# **Appendix I** Traffic Impact Assessment

# GLEN INNES SEVERN COUNCIL QUARRY TRAFFIC IMPACT ASSESSMENT

**Re: Glen Innes Wind Power Entry WAD Drawings Submission – RMS Comments**

# ROADS AND MARITIME SERVICES

PROPOSED CHR(S) & AUL(S) LAYOUT  
SIGNAGE & LINEMARKING  
SCALE 1:1000

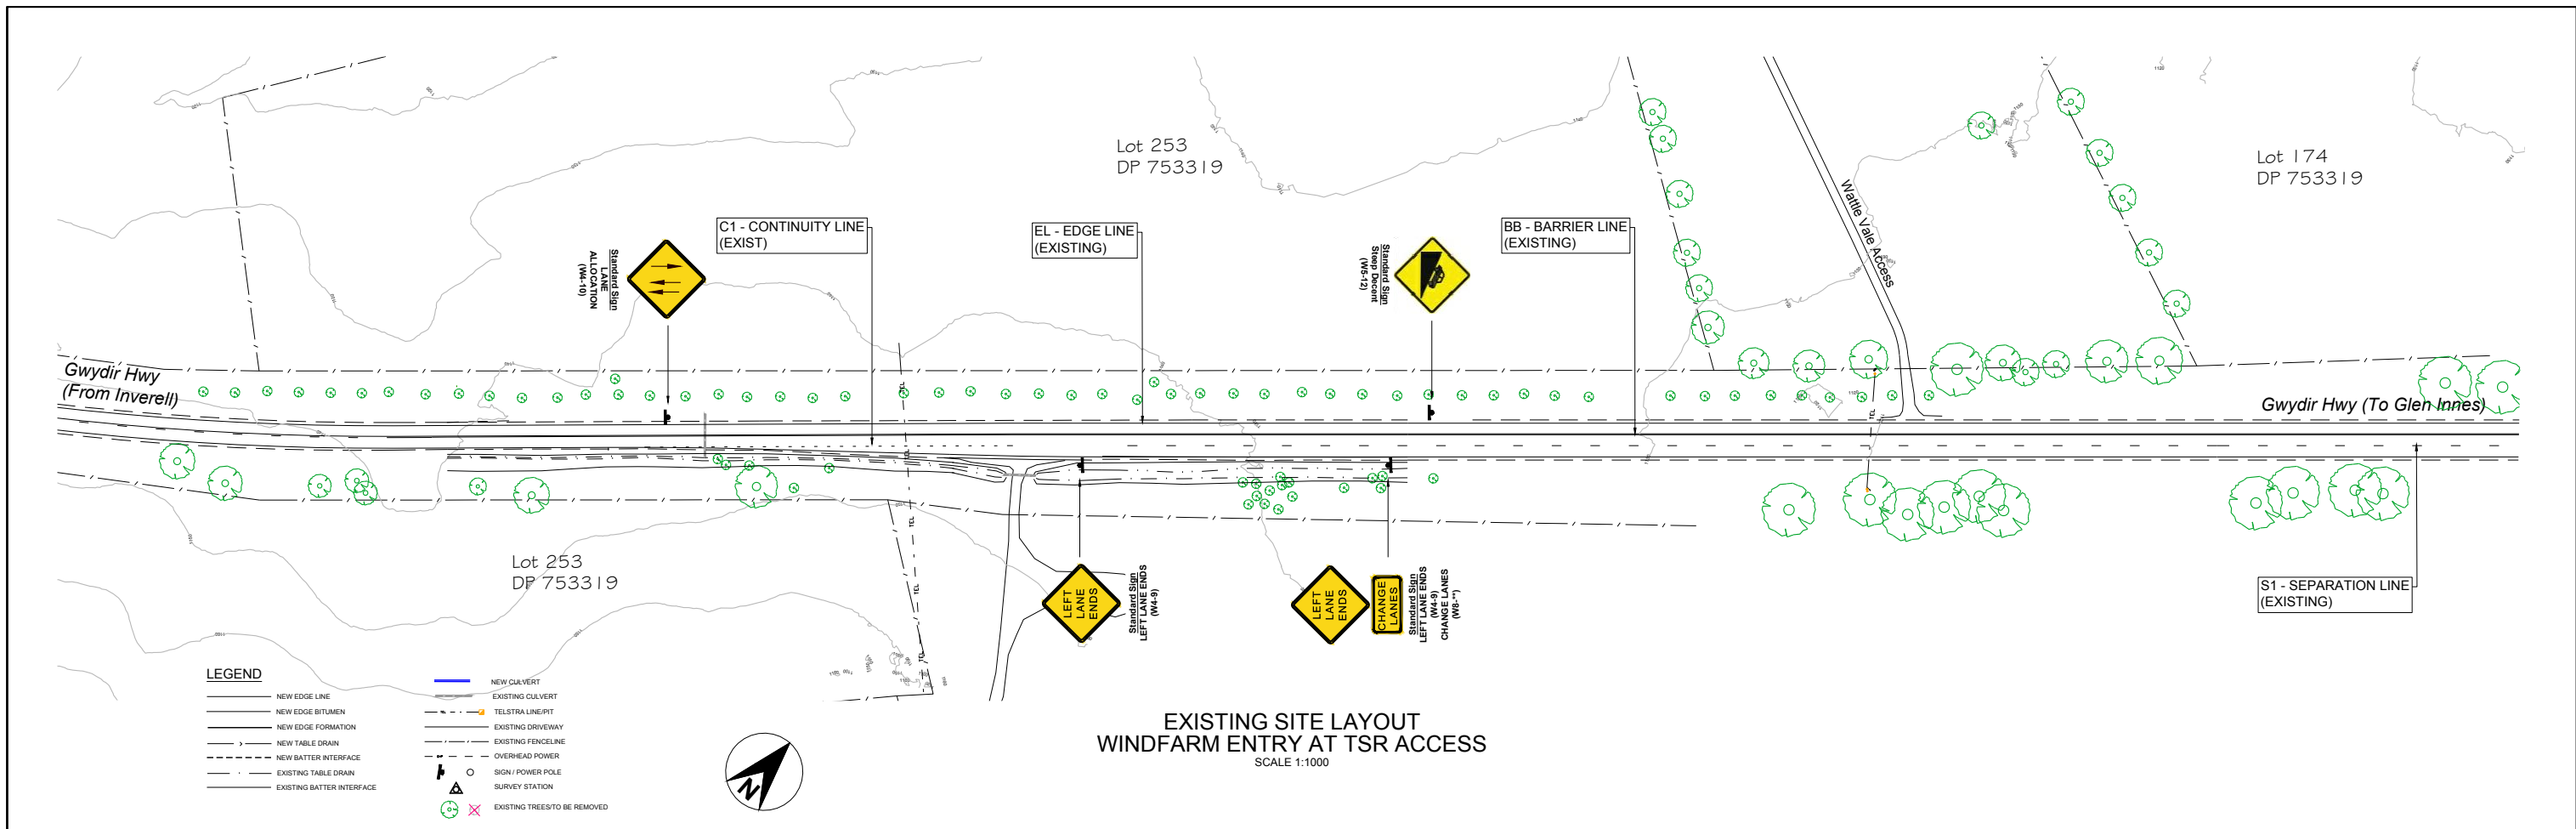
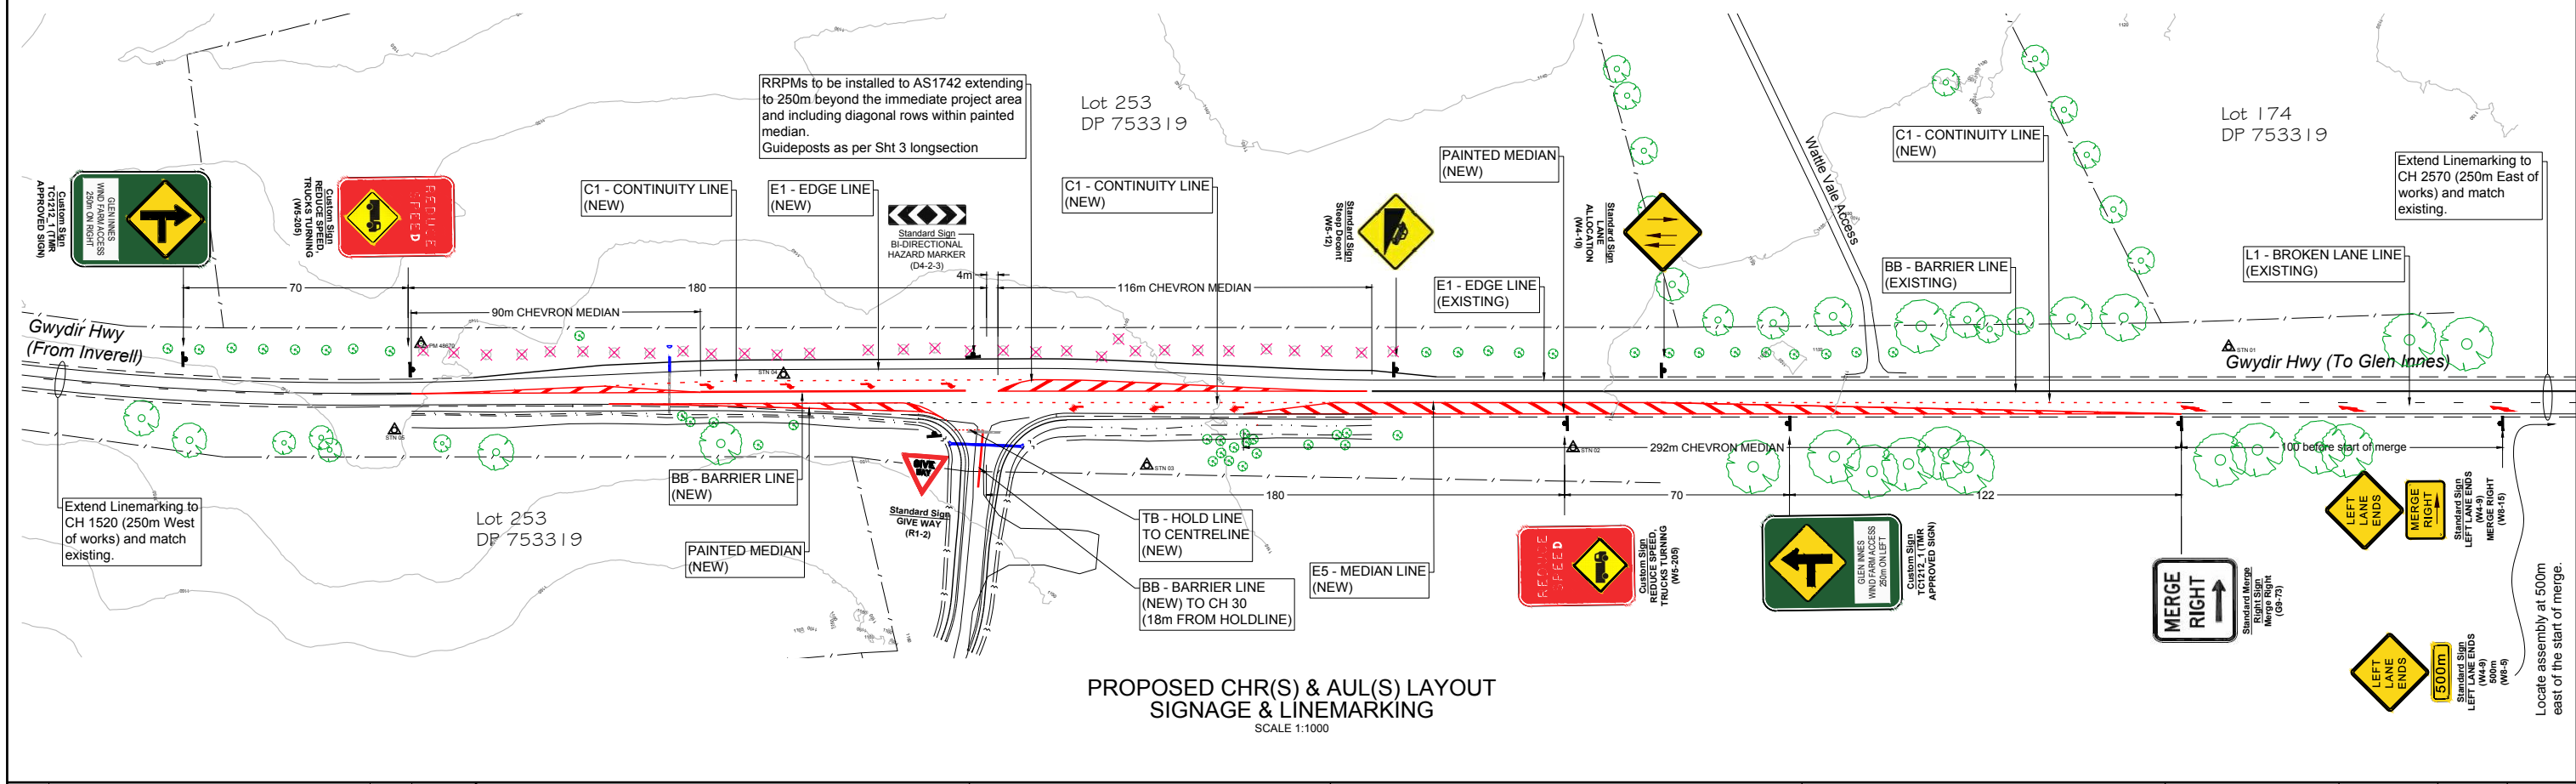
- Sealed shoulder has been increased to 3m between chainages 1830 and 2070 to provide a safe run-off area to compensate for the non-compliant SISD to the west, to cater for vehicles encountering a slow moving vehicle making a right turning exit into the new road, or a slow moving vehicle making a right turn entry from the new road.

- Elsewhere, sealed shoulders have been increased from 0.5 to 1m
- Merge arrows have been added at the end of the overtaking lane in accordance with AS1742.2

- Correction to line marking notations (L1 and E1)
- Superseded warning sign (W5-205) has been replaced with W5-22 truck symbolic sign.
- The pavement notes and details on sheet 6 have been updated to reflect the previous RMS comments on the geotechnical design, made in an email

TYPICAL SECTION 1  
PAVEMENT WIDENING OUTSIDE EXISTING LANE  
Scale 1:50

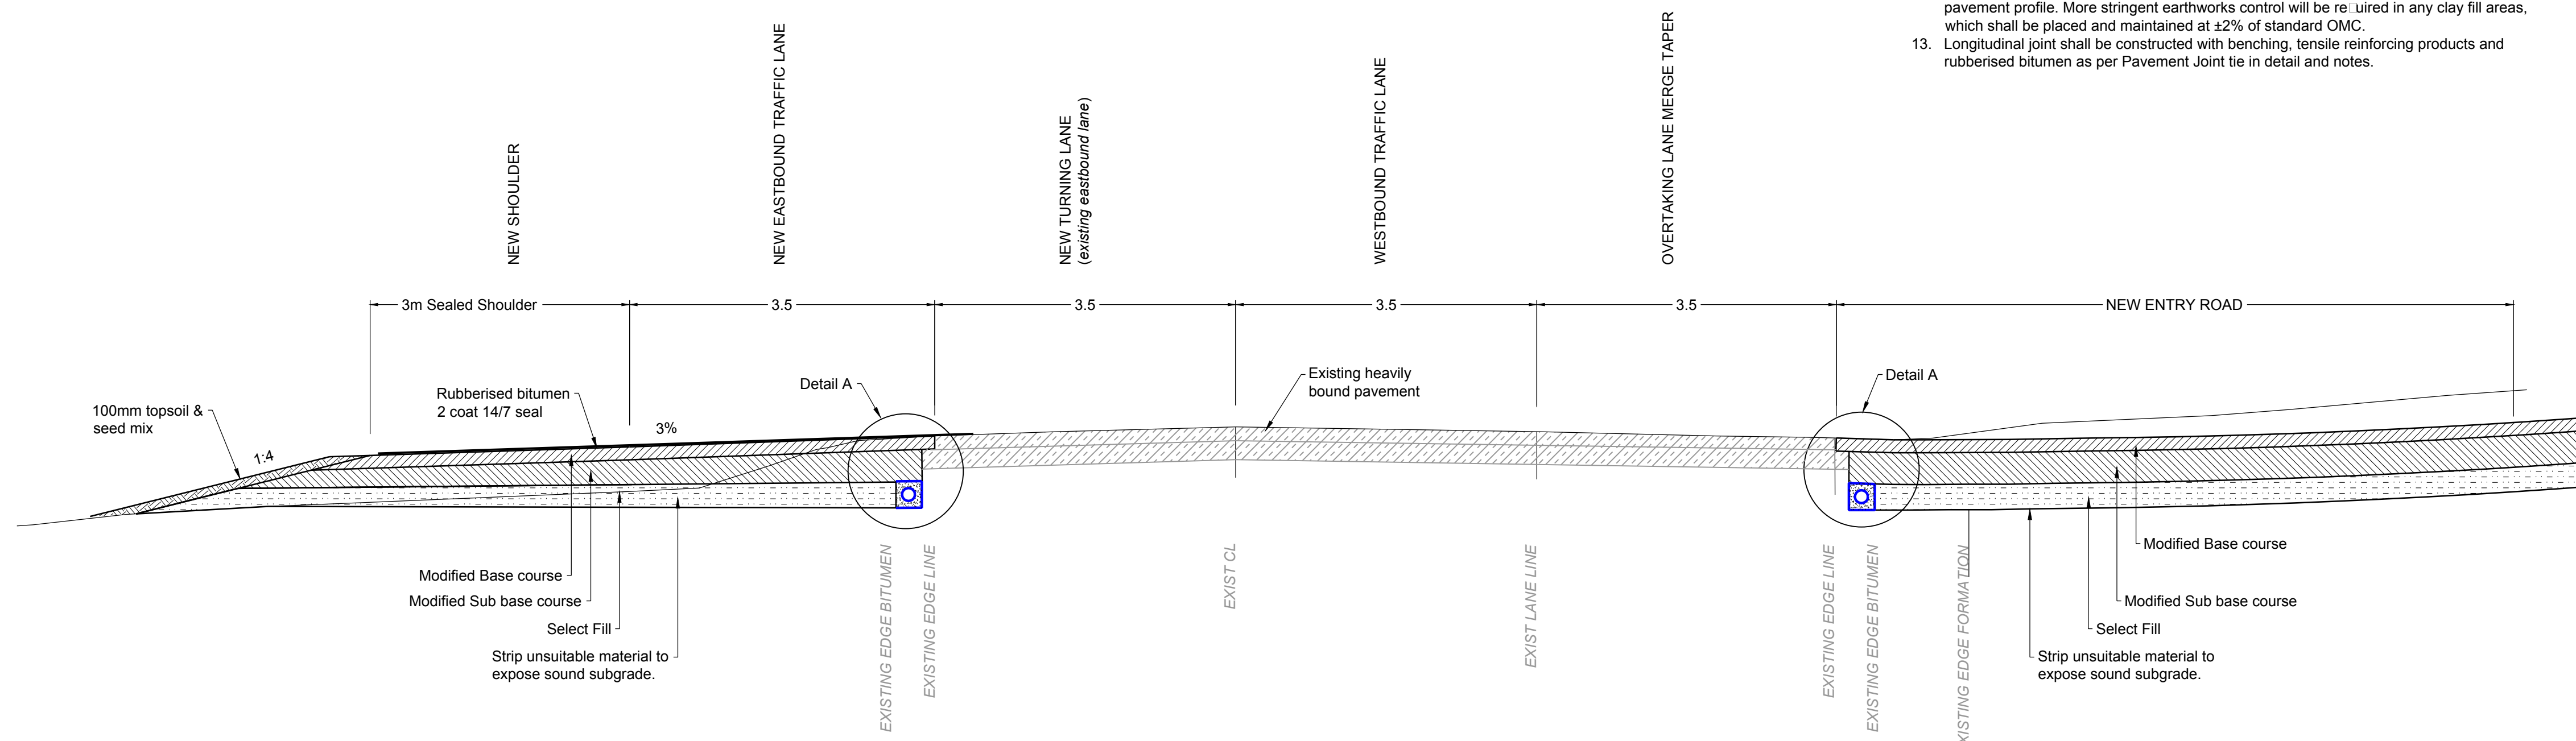
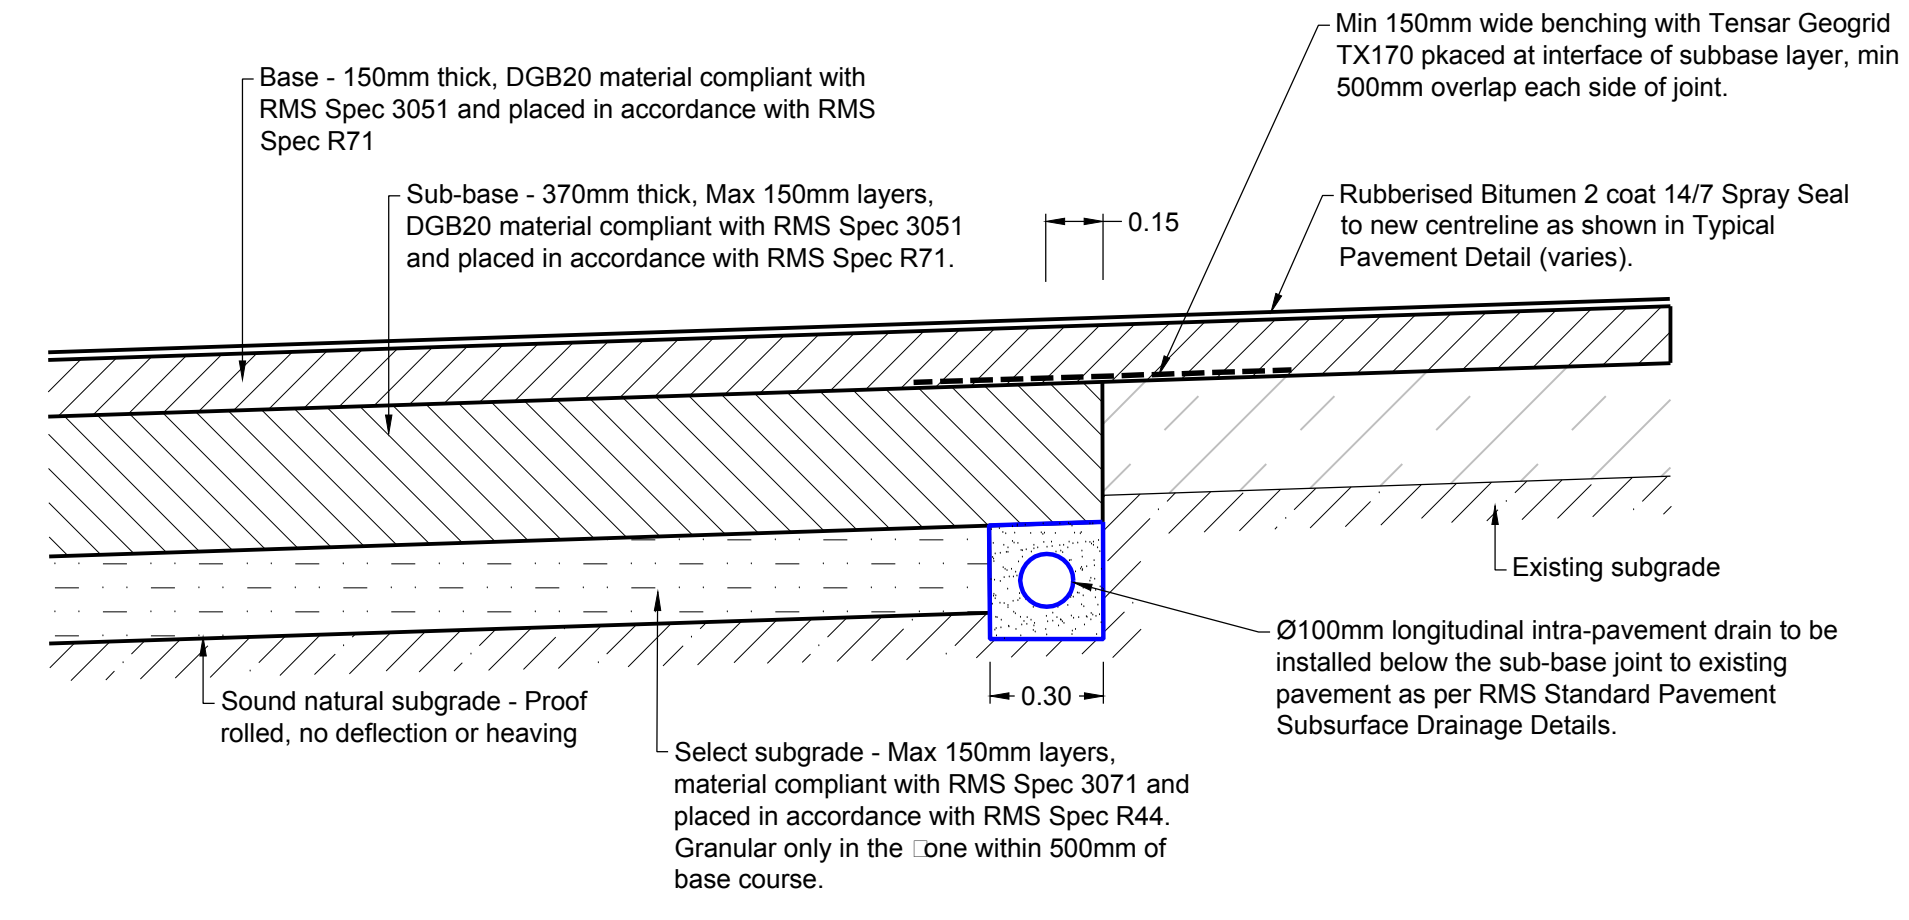
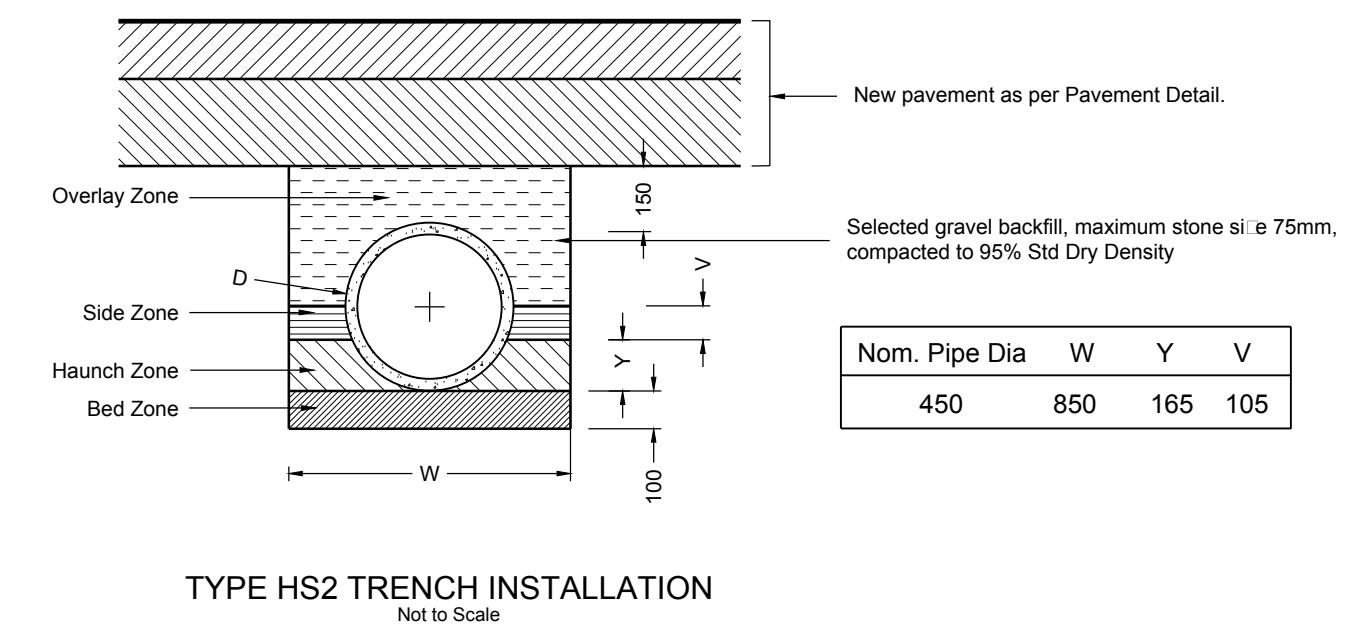
With regard to the RMS review of Geotechnical Report (RGS 30969.1-AB) and comments made by email dated 28/11/16, RGS have amended their report (RGS 30969.1-AB Rev.1 14/12/16) and we made the following amendments to the design drawings:

- The RMS requirements for a minimum acceptable pavement thickness of 450mm is noted.
- Detailed investigations were carried out at a site 850m west of this intersection, and limited investigation at this actual site. Although CBR values of 6 and 13 were found on the southern shoulder, no CBR results were taken on the northern shoulder. Therefore, as a more conservative approach, the design has been revised based on the lowest CBR of 4 encountered at the western location.

- On this basis, and considering the stated preference by RMS for the new pavement to be a granular pavement with no modification or stabilisation, a pavement thickness of 520mm has been adopted.

- An interface drain has been added between the existing and new pavement, and located below the 520mm pavement thickness, and located under the joint in the sub base layer along the line of the original edge line, with outlets to batters at spacings in accordance with RMS STD Drawings.

- Tensar grid reinforcing will be laid over this joint below the base course.
- Wearing course will be a two coat seal, and all references to AC have been removed.
